**REQUEST**

Current Zoning: R-12MF(CD) (Multi-Family Residential, Conditional)  
Proposed Zoning: N2-A(CD) (Neighborhood 2-A, Conditional)

**SUMMARY OF PETITION**

The petition proposes the development of up to 37 multi-family attached units. The site is currently developed with a medical office.

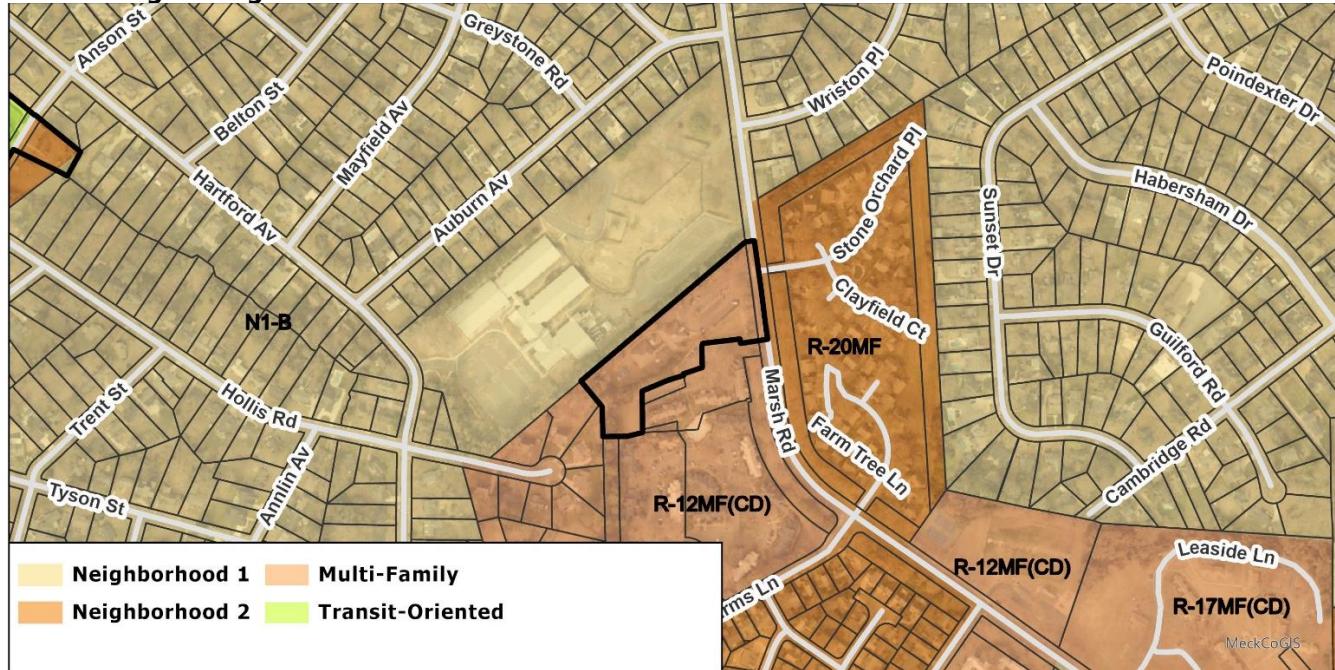
1. CDOT: Revise site plan and conditional note(s) to clarify a 40' vehicle turn around between gated entrance and back of sidewalk. **ADDRESSED**

2. Fire: Must be a minimum width of 20 feet for undivided entry/exit or 16 feet for divided entry/exit. **ADDRESSED**

5. Entitlement Services: There is an approximately 60' berm along the front of the property. Adjust the site design to be consistent with existing development along Marsh Road which incorporates large setbacks. **ADDRESSED**

7. Urban Design: Expand the footprint of open space and increase minimum open space dimension. The allocation of 10' in front of the units for open space is narrow and will not be ample to program or activate with quality open space. **ADDRESSED**
